PARTIAL LEVEL-09 FRAMING PLAN (PHASE-1) (SEQ#12)

SK#20
One page
One Query
Date: 06-27-2025

PROJ. NO. :	25001	REV # B
DWG NO. :	E1201

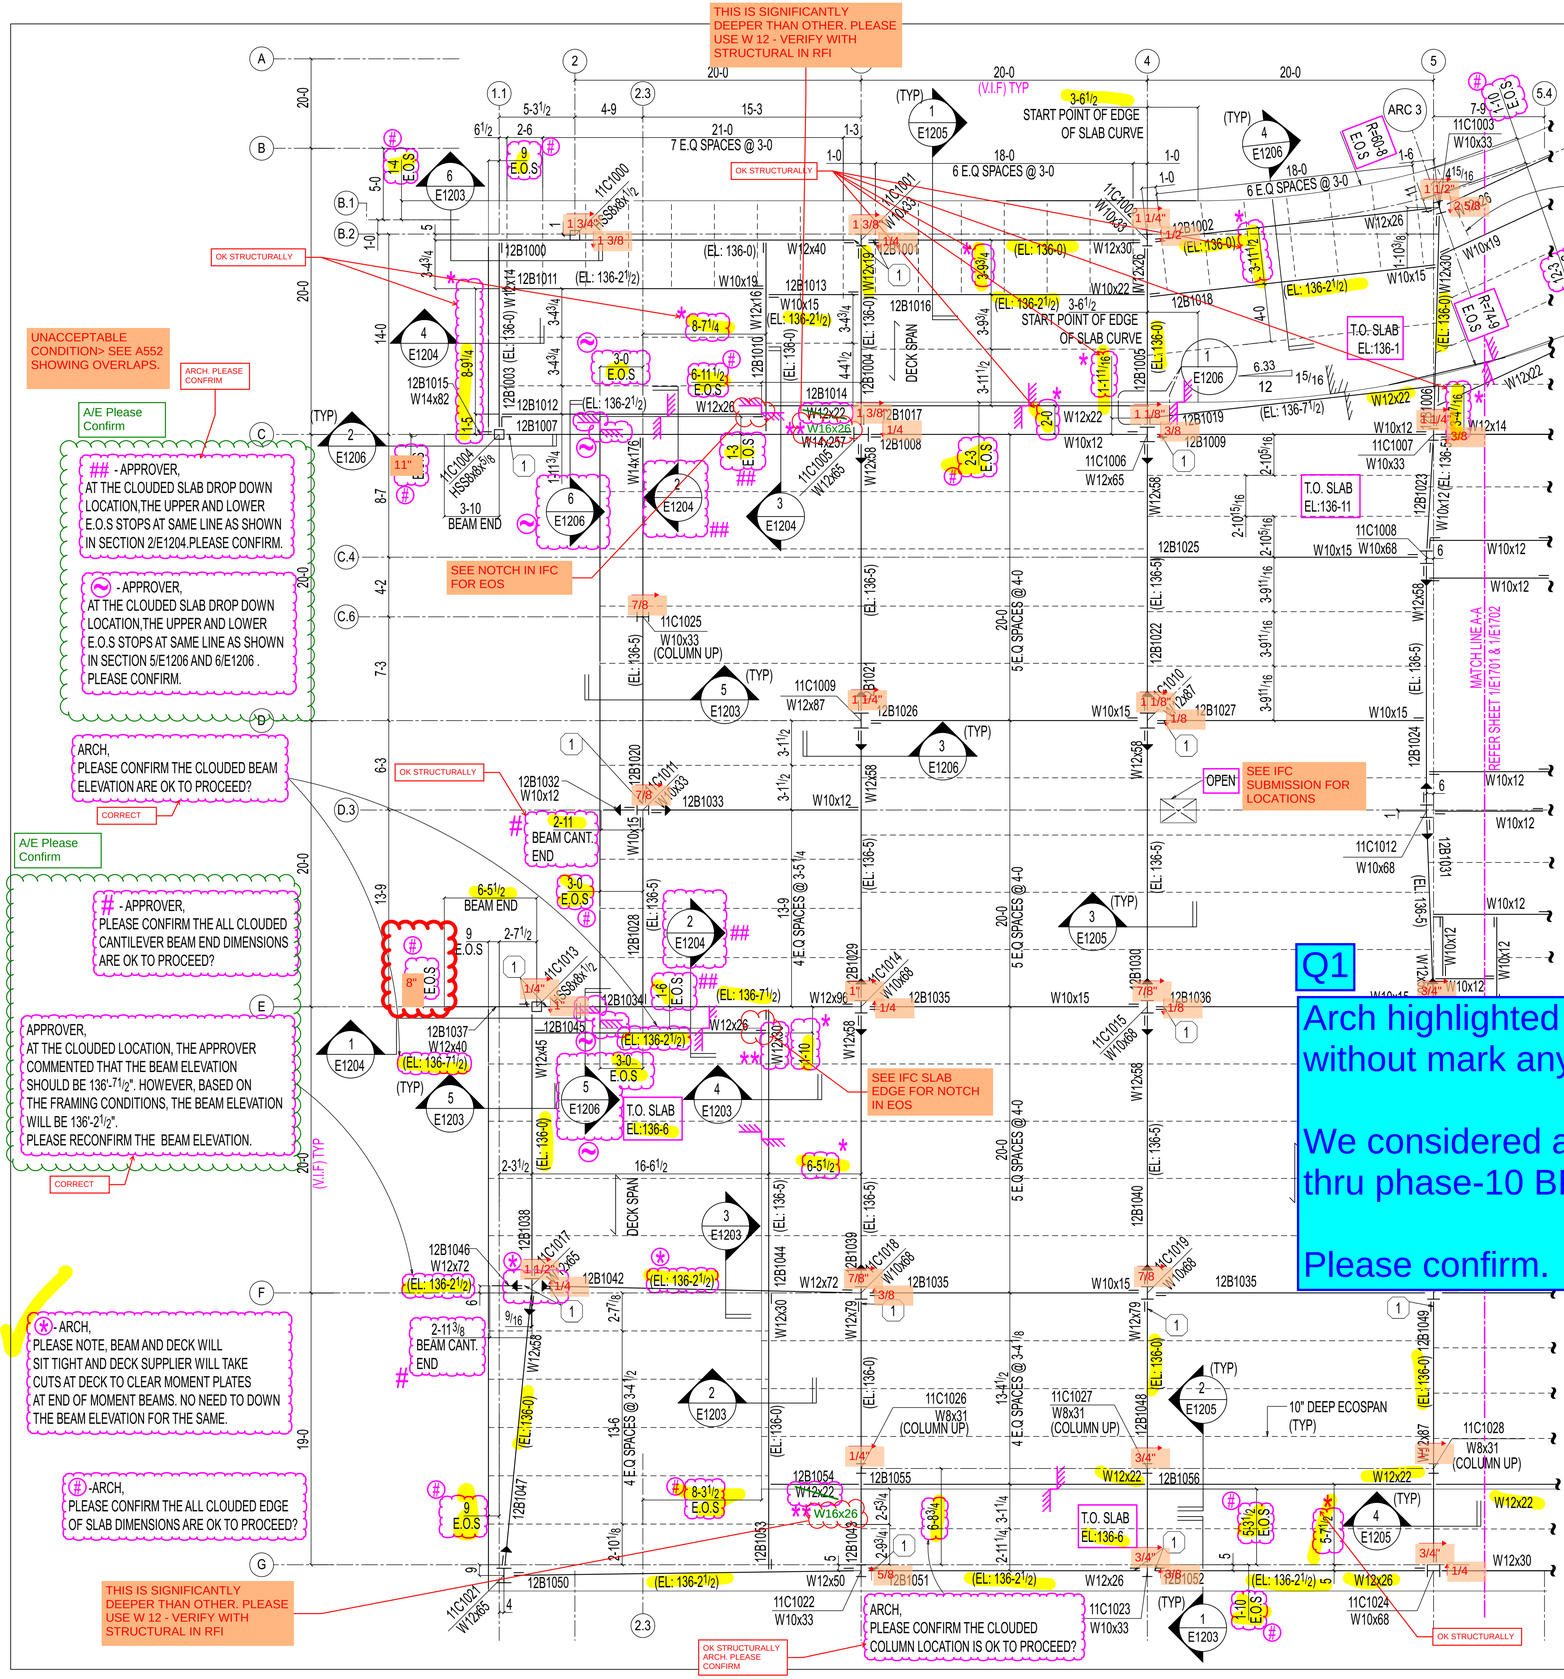
KEY: TYPICAL
-EXISTING COL LOCATION PER VIKA SCAN.
-NEW COLUMN CANNOT EXCEED 1/2" OFF EXISTING COLUMN AXIS.
1 3/4"
1 3/8

A/E Please Confirm

* -APPROVER, AS PER THE APPROVER'S RETURNS COMMENT STATED THAT COORDINATE WITH ARCHITECTURAL SLAB EDGE PLANS FOR BEAM LOCATION. WE HAVE REVIEWED THE 1/A057 SLAB EDGE PLAN BUT WERE UNABLE TO LOCATE SOME OF THE BEAM LOCATIONS. PLEASE CONFIRM WHETHER ALL CLOUDED BEAM LOCATIONS ARE OK TO PROCEED.

** -APPROVER, AS PER THE APPROVER'S RETURNS ARCH COMMENT, WE HAVE CHANGED BEAM SECTION SIZE.PLEASE CONFIRM ALL CLOUDED BEAM SECTION SIZE.

Q1

Arch highlighted most of our queries/clouded items in yellow without mark any comments.

We considered all yellow highlighted items by arch from Phase-1 thru phase-10 BFA sheets as OK to proceed.

Please confirm.
